Technical Bulletin: 1/4" Copper Tube Failures

Rev.: 26 Feb 2016
P/N: TB16.003

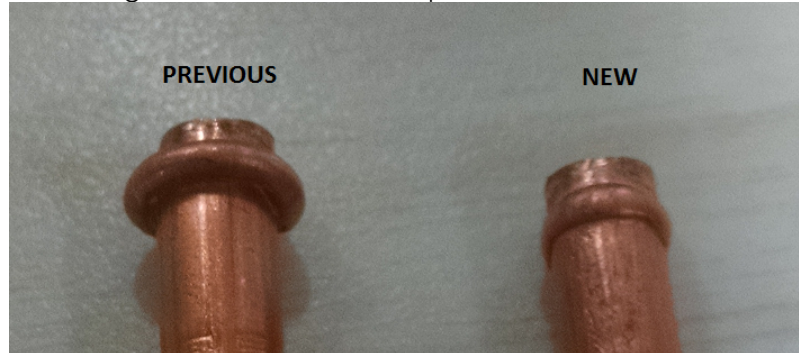
On February 10, 2015, Enertech released a bulletin highlighting the discovery of a quality issue regarding breaking 1/4" copper tubes. During the investigation into this issue, it became apparent that there is an additional quality issue regarding the amount of fill material used on braze joints. In some cases, brazing operators failed to apply enough fill material to ensure a solid joint. This has mostly been reported on 1/4" lines containing the bead stop. See picture below.

1. The details of this issue have been widely communicated with plant personnel.
2. Additional training has been completed by brazing operators.
3. Additional quality checks throughout the manufacturing process have been added to ensure braze joints are of acceptable quality.
4. Employees have been and will continue to inspect and where necessary repair stock units.
